STAFF REPORT
COMMUNITY DEVELOPMENT DEPARTMENT

HEARING DATE: October 21, 2021
 TO: Planning & Zoning Commission
 FROM: Sonya Allen, Associate Planner
 208-884-5533
 SUBJECT: H-2021-0065
 Aviator Springs – AZ, PP
 LOCATION: 3235 N. McDermott Rd., in the SE ¼ of Section 32, T.4N., R.1W. (Parcels #R7824220044 & #R7824220042)

Annexation of 40 acres of land with R-8 (31.59 acres), L-O (1.64 acres) and M-E (6.77 acres) zoning districts; and Preliminary plat containing a total of 112 lots consisting of (93) buildable lots and (13) common open space lots on 31.59 acres of land in the R-8 zoning district; (2) buildable lots on 1.64 acres of land in the L-O zoning district; (1) buildable lot on 6.77 acres of land in the M-E zoning district; and (3) future right-of-way lots on 40 acres of land.

Preliminary Plat Overview
 PP-01

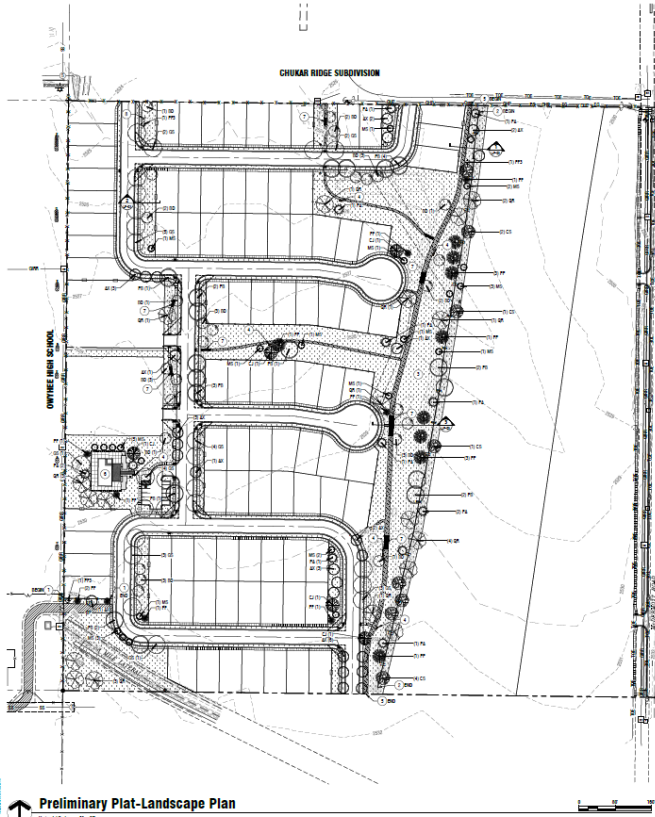
- “Encourage a variety of housing types that meet the needs, preferences, and financial capabilities of Meridian’s present and future residents.” (2.01.02D)
*Only one housing type, single-family detached, is proposed in this development. Other housing types (i.e. single-family attached units, townhomes, secondary dwellings or multi-family) could be added to this development for variety, which would increase the density of the development more in line with the guidelines for mixed use designated areas. However, because of the limited access to this site, Staff is hesitant to recommend more units be provided in this development. **If Commission feels a variety of housing types at a higher density should be provided more in line with the MU-N designation, Commission should require revisions to the plat accordingly.***

Access is proposed to the western portion of the development via the extension of two (2) local streets from the north from Chukar Ridge Subdivision. Future SH-16 is planned to bisect this site on Lot 1, Block 5. Access is proposed to the eastern portion of the site via N. McDermott Rd. Direct access via future SH-16 is prohibited. One (1) stub street is proposed to the south for future extension and interconnectivity.

Typically, a street generally paralleling the state highway is required with development to provide connectivity and access to all properties fronting the state highway that lie between the Applicant's property and the nearest section line road and/or half mile collector road. Because the developments to the north (i.e. Chukar Ridge & Gander Creek) did not provide such a road, Staff is not requiring one with this development. The stub street to the south is located at the back edge of the street buffer along future SH-16, which can be extended to the south to Ustick Rd. in accord with UDC 11-3H-4B.3.

The Pathways Master Plan does not depict any required multi-use pathways on this property. A 10' wide multi-use pathway is proposed within the common open space area adjacent to future SH-16. **The pathway is required to be placed in a 14-foot wide public use easement, which shall be submitted to the Planning Division prior to submittal for City Engineer signature on the final plat(s) for Phase 1.**

- b. Include a note prohibiting access to future SH-16.
 3. The landscape plan submitted with the final plat shall be revised as follows:
 - a. Add Class II trees and landscaping within all parkways within the development in accord with the standards listed in UDC 11-3A-17E and 11-3B-7C as desired in MU-N designated areas.

4. A 14-foot wide public use easement shall be submitted to the Planning Division for the multi-use pathway within the common open space area along future SH-16 prior to submittal of the Phase 1 final plat for City Engineer signature.

Preliminary Plat
 Landscape Plan

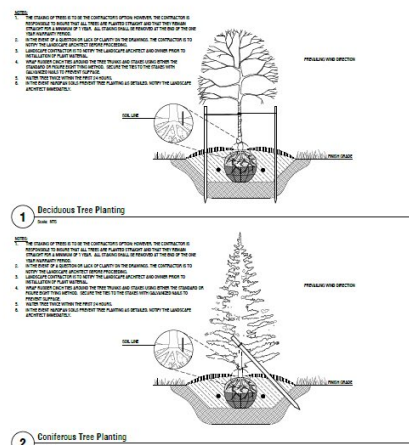
Eight-foot wide parkways are proposed along all internal public streets where detached sidewalks are proposed. All parkways should be constructed in accord with the standards listed in UDC [11-3A-17E](#). **Because tree-lined streets are desired in MU-N designated areas, Staff recommends trees and landscaping are added within all parkways per the standards in UDC 11-3A-17E and 11-3B-7C.**

A 35-foot wide street buffer is required on both sides of future SH-16, a state highway and entryway corridor. Landscaping is required to be installed within the buffer per the standards listed in [UDC 11-3B-7C](#), which require a *mix* of trees and shrubs, lawn, or other vegetative groundcover – shrub should be included in the buffer in accord with this standard. A dense buffer is proposed on the west side of future SH-16 consisting of a mix of deciduous & coniferous trees; **shrubs should be added as required by UDC 11-3B-7C. No buffer is depicted on the east side of future SH-16; a minimum 35-foot wide street buffer is required in a common lot or a permanent dedicated buffer with landscaping included on the landscape plan in accord with UDC standards.**

Landscaping is required adjacent to all pathways per the standards in UDC [11-3B-12C](#). A 5' wide landscape strip is required on both sides of pathways planted with a *mix* of trees, shrubs, lawn and/or other vegetative ground cover. **The Landscape Requirements table should include the linear feet of pathway with the required vs. proposed number of trees to demonstrate compliance with UDC standards.**

Landscaping is required within parkways per the standards listed in UDC [11-3A-17](#) and [11-3B-7C](#). **The Landscape Requirements table should include the linear feet of parkways within the development with the required vs. proposed number of trees to demonstrate compliance with UDC standards.**

Noise abatement is required for residential uses adjoining a state highway. A berm or berm and wall combination is required to be constructed parallel to the state highway that meets the standards listed in UDC 11-3H-4D. A 6-foot tall fence/wall is proposed on the landscape plan that does *not* meet the required standards as there is no berm proposed.

In accord with City Council’s direction on previous developments to the north (i.e. Chukar Ridge & Gander Creek subdivisions), Staff recommends a 6-foot tall berm with a 6-foot tall wall on top of the berm is constructed within the buffer along future SH-16. The berm/wall is required to be a minimum of 10-feet higher than the elevation at the centerline of the state highway; the wall must meet the standards in UDC 11-3H-4D.3. A detail of the proposed berm/wall combination that demonstrates compliance with the standards listed in UDC 11-3H-4D should be submitted with the final plat for the first phase of development. Alternative compliance may be approved by the Director as set forth in UDC 11-5B-5 where the applicant has a substitute noise abatement proposal in accord with ITD standards and prepared by a qualified sound engineer per UDC 11-3H-4D.4.

- d. Include a detail of the berm or berm and wall combination required for noise abatement along future SH-16 that demonstrates compliance with the standards listed in UDC 11-3H-4D and is consistent with what City Council required on previous developments to the north (i.e. Chukar Ridge & Gander Creek – a 6-foot tall berm with a 6-foot tall wall on top of the berm); or apply for alternative compliance as allowed by UDC 11-3H-4D.4 as set forth in UDC 11-5B-5.
